DEVELOPMENT APPLICATION PDPLANPMTD-2023/041206

PROPOSAL: Two Warehouses, Signage and Change of Use to

LOCATION: 14 Spark Drive, Cambridge

PDPLANPMTD-2023/041206 - 14 Spark Drive, Cambridge

Site Plan 7/3 Abernant Way, Cambridge 7170 admin@pinnacledrafting.com.au www.pinnacledrafting.com.au Approved by:

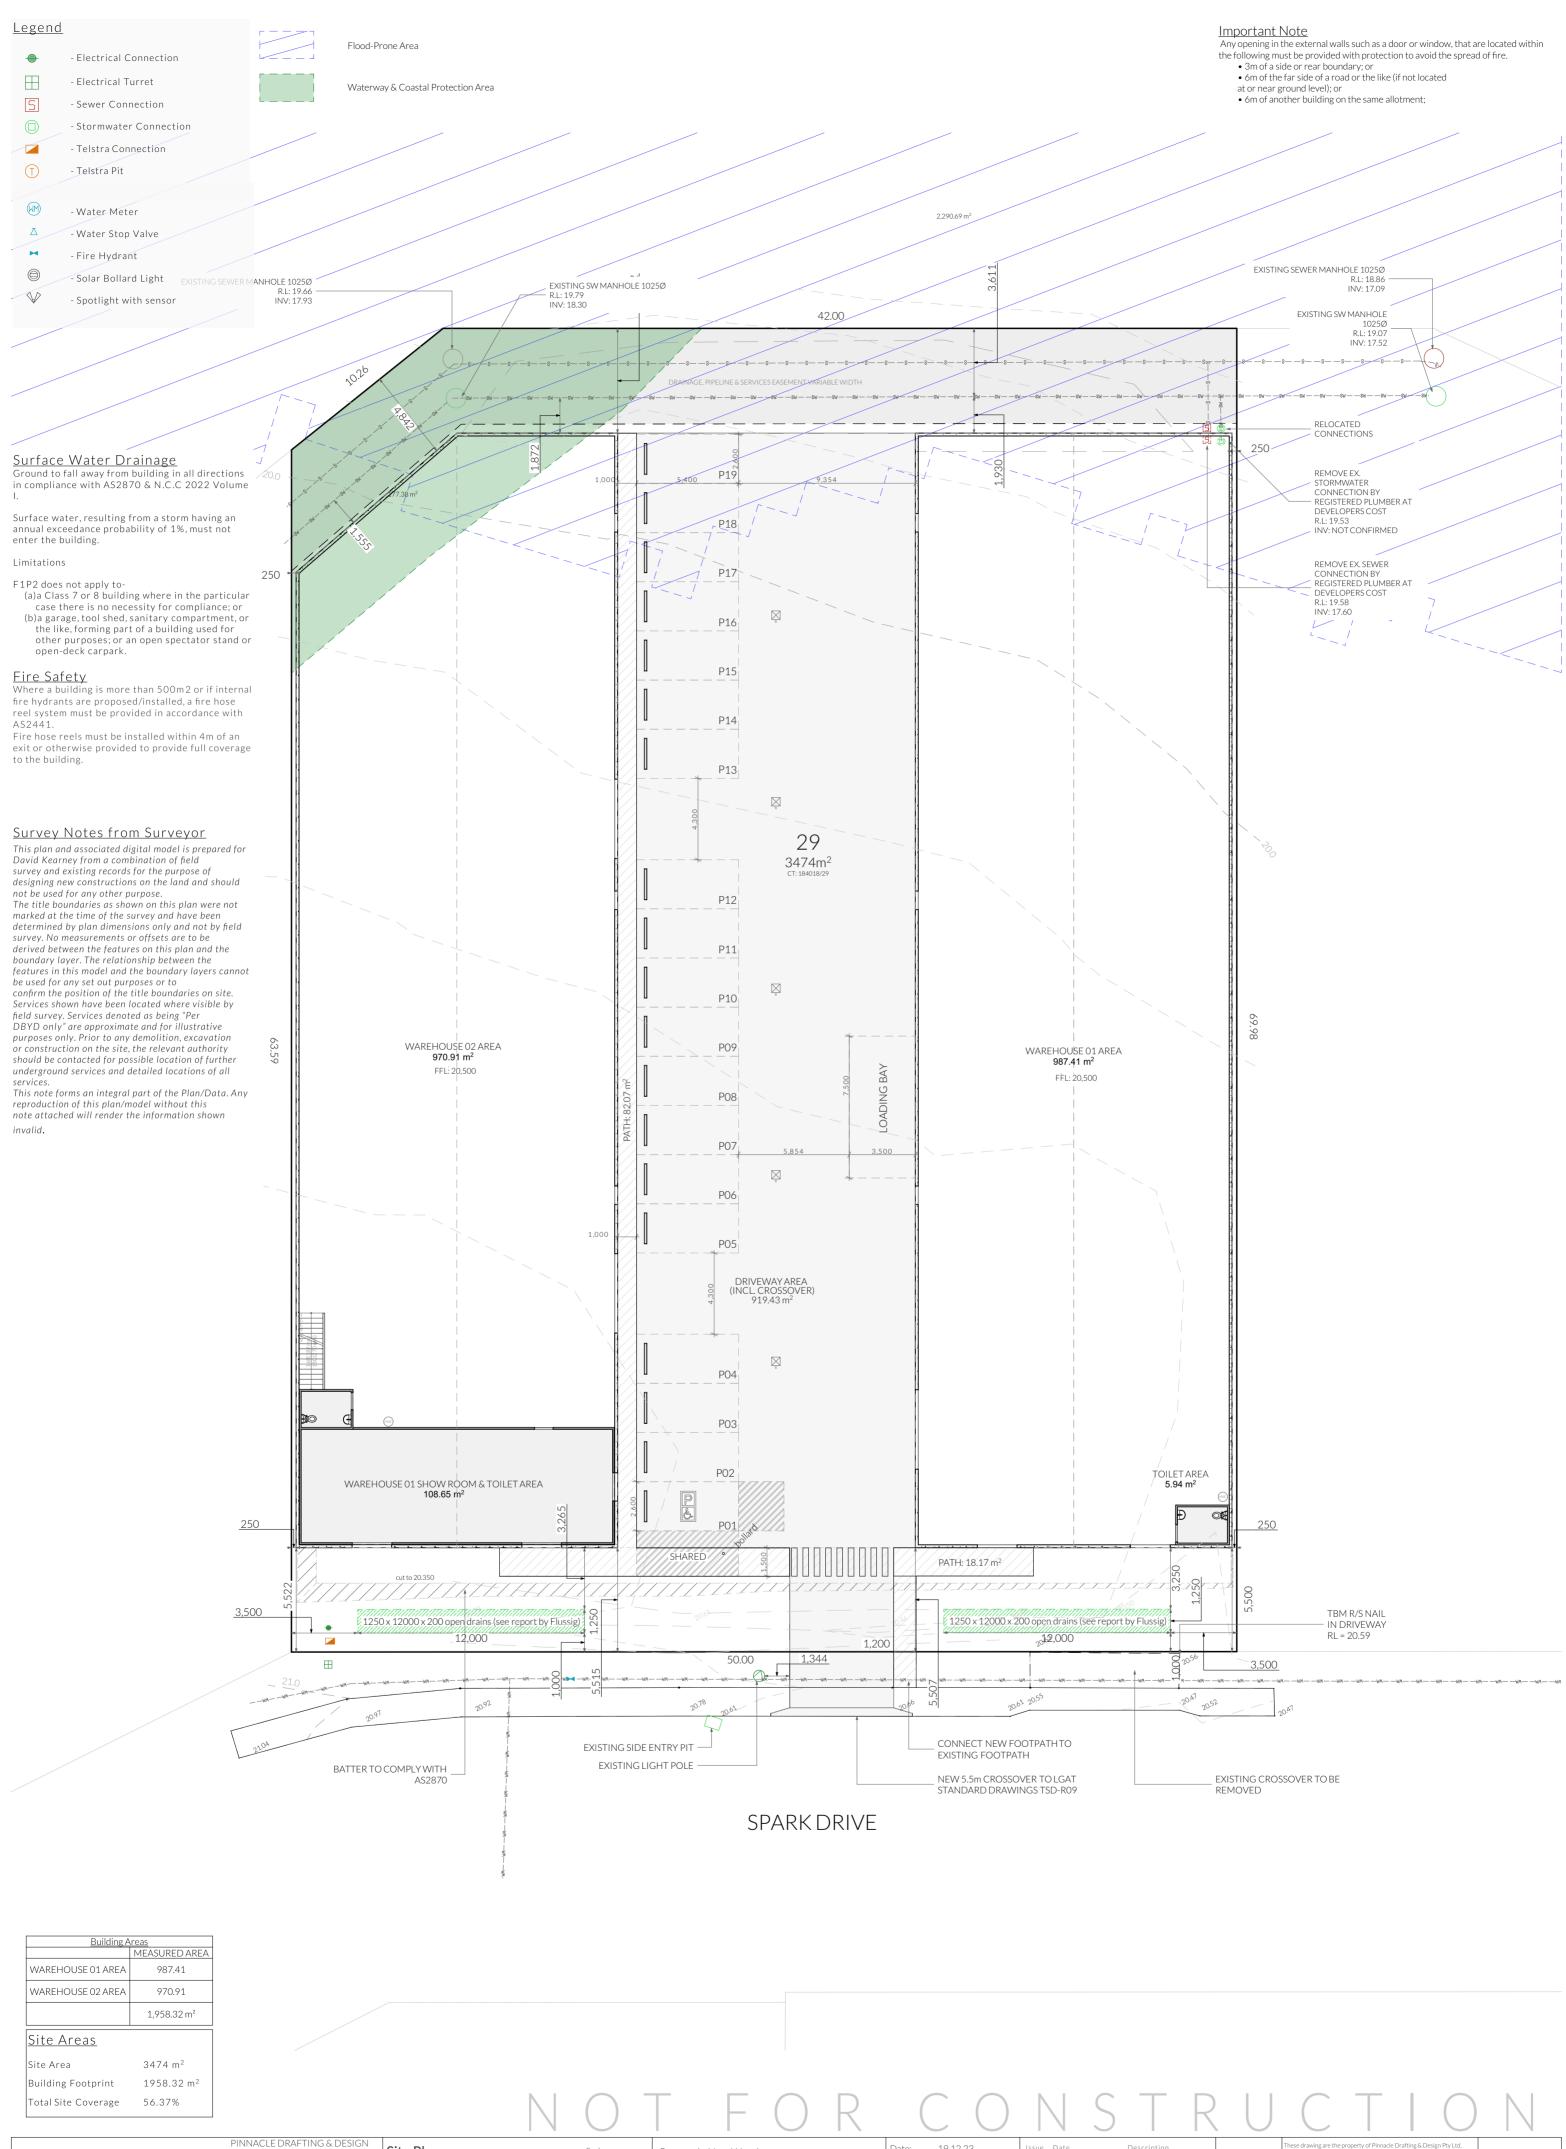
- 5 Natural Assets Code C7.6.1 Buildings and works within a waterway and coastal protection area or future coastal refugia area
 - A waterway protection area is present at the rear of the site, please show the location of the waterway protection area on the site plan. In addition, if any building works are located within the overlay, please demonstrate compliance with the relevant performance criteria of clause C7.6.1 P1.1 of the Scheme.

- 6 Flood-prone Hazard Code C12.6 Development Standards for Buildings and Works
 - As the Flood Report recommends open drainage along the southern boundary, please amend the Site Plan and Landscape Plan to show that it is consistent with the recommendations of the Flood Report.

Mapping as been show on the Site Plan. A report has been commissioned to address Clause C7.6.1 P1.1

Site & Landscaping Plans have been amended to include this.
